# Technical Note

## MT9T012 Revision 1 Features

This technical note addresses the Micron<sup>®</sup> MT9T012 Revision 1 CMOS image sensor, which adds an additional processing step to the digital data path in order to provide color-dependent lens correction (position-dependent digital gain control). This revision has a number of additional functional changes to improve the operation of the sensor.

**Figure 1: MT9T012 Revision 1 System States**

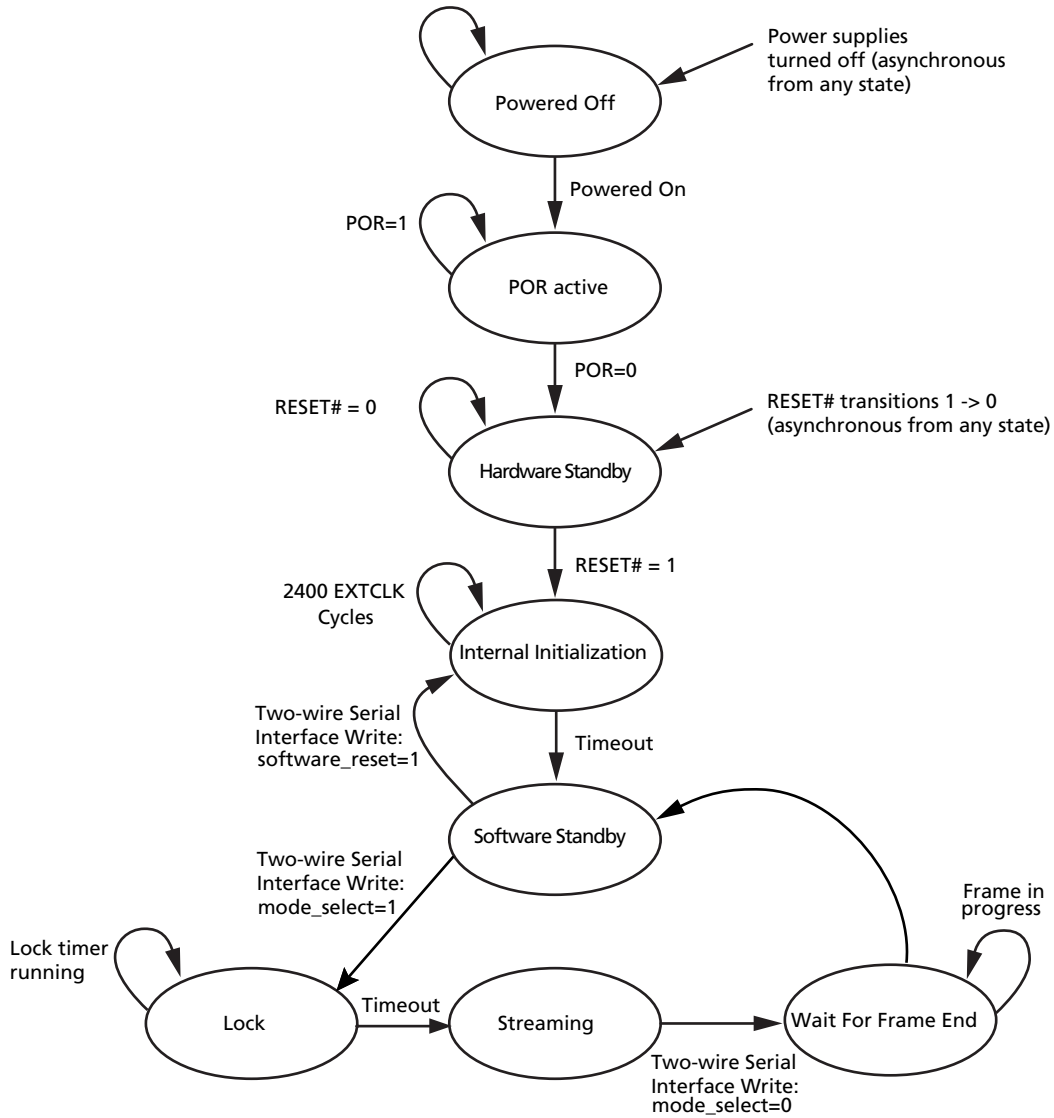
MT9T012 Revision 1 implements a PLL lock timer and powers down the PLL VCO while the sensor is in software standby. As a result, the power consumption is reduced while the sensor is in software standby. When the sensor enters streaming mode (`mode_select = 1`) streaming does not commence until the PLL has acquired lock. This change introduces a new state to the System State machine, as shown in Figure 1 on page 4. The effect of `RESET#` on the system state and the configuration of the PLL in the different states are shown in Table 3 on page 4.
